APPLICATION NO.	FILING DATE	FIRST NAMED INVENTOR	ATTORNEY DOCKET NO.	CONFIRMATION NO.
10/758,012	01/16/2004	Tomoyuki Kojima	0051-0217P	5749
2292 7590 06/04/2009 BIRCH STEWART KOLASCH & BIRCH PO BOX 747 FALLS CHURCH, VA 22040-0747				
EXAMINER				
MCALISTER, WILLIAM M				
ART UNIT		PAPER NUMBER		
3753				
NOTIFICATION DATE		DELIVERY MODE		
06/04/2009		ELECTRONIC

Office Action Summary

DETAILED ACTION

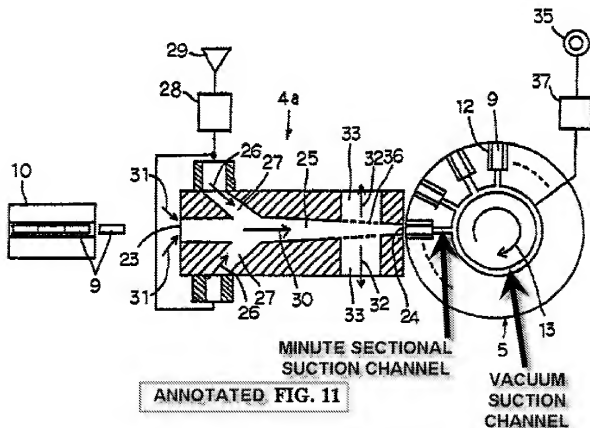
a vacuum suction channel (see annotated FIG 7 below),

each work receiving opening being connected to the vacuum suction channel, through a minute sectional suction channel provided on the conveyor

table (see annotated FIG 11), the sectional area of the minute sectional channel being smaller than that of the vacuum suction channel (as seen in FIG 11, the minute sectional suction channels are smaller (shorter) than the vacuum suction channel).
